# Access Compliance Report

## Public Rights-of-Way

### (Curb Ramps)

Intersection ID: 17577	Main Street: HARRIS_RD	Cross Street: PROVIDENCE_RD	Location: SW
ADA ID: B7171DE4F980	Ramp Type: PerpDiag	Initial Pass/Fail: Fail	Overall Compliance: No
			Severity Score: 33.75

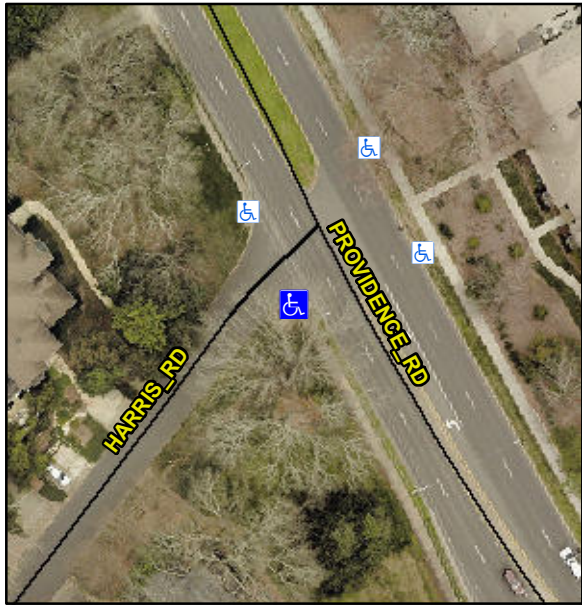
Codes/Mitigation Info/Possible Solution			Field Measurements/Component Compliance					
	Possible Solutions:		Compliance	Description	Data	Compliance	Description	Data
	<b>Remove &amp; Replace Curb Ramp With Two New Directional Ramps or Equivalent.</b>		N/A	Ramp Length (in)	38.0	No	Ramp Slope (%)	9.7
			No	Ramp Width (in)	43.0	No	Ramp XSlope (%)	5.3
			N/A	Flare Type LT	N/A	N/A	Flare Type RT	N/A
			N/A	Flare Slope LT (%)	N/A	N/A	Flare Slope RT (%)	N/A
			N/A	Flare Traversable LT?	N/A	N/A	Flare Traversable RT?	N/A
			N/A	Landing Length (in)	N/A	N/A	DWS Provided?	N/A
			N/A	Landing Width (in)	N/A	N/A	DWS Contrast?	N/A
			N/A	Landing Slope (%)	N/A	N/A	DWS Length (in)	N/A
			N/A	Landing X Slope (%)	N/A	N/A	DWS Full Width?	N/A
Surveyor Notes:		N/A	N/A	Landing Curb? (Y/N)	N/A	N/A	DWS Offset (in)	N/A
PROW/ADA:		Not Found, R304.5.1, R304.2.2, R304.5.3	N/A	Shared Landing?	N/A	N/A	Gutter Slope (%)	N/A
			N/A	Gutter Ponding?	N/A	N/A	Gutter X Slope (%)	N/A

N/A	Gutter Lip Ht (in)	N/A	N/A	Painted X Walk2?	No
				Painted X Walk1?	No	N/A	X Walk 2 Direction	To NW
				X Walk 1 Direction	To E		X Walk 2 Width (in)	N/A
			N/A	X Walk 1 Width (in)	N/A	N/A	X Walk 2 Slope (%)	4.2
				X Walk 1 Slope (%)	0.6		X Walk 2 X Slope (%)	7.3
				X Walk 1 X Slope (%)	3.1		Ramp inside XWalk2?	N/A
			N/A	Ramp inside XWalk1?	N/A	N/A	Clear Space?	N/A
				Road Slope (%)	3.1	N/A	Clear Space to XWalk (in)	N/A
				Road X Slope (%)	1.7	N/A	Storm Grate/Utility Hazard?	N/A
			N/A	Any Obstructions?	N/A	N/A	Storm Grate/Utility Type	
				Obstruction Type				
						N/A		N/A
						Yes	Surface Condition? (G/P)	Good
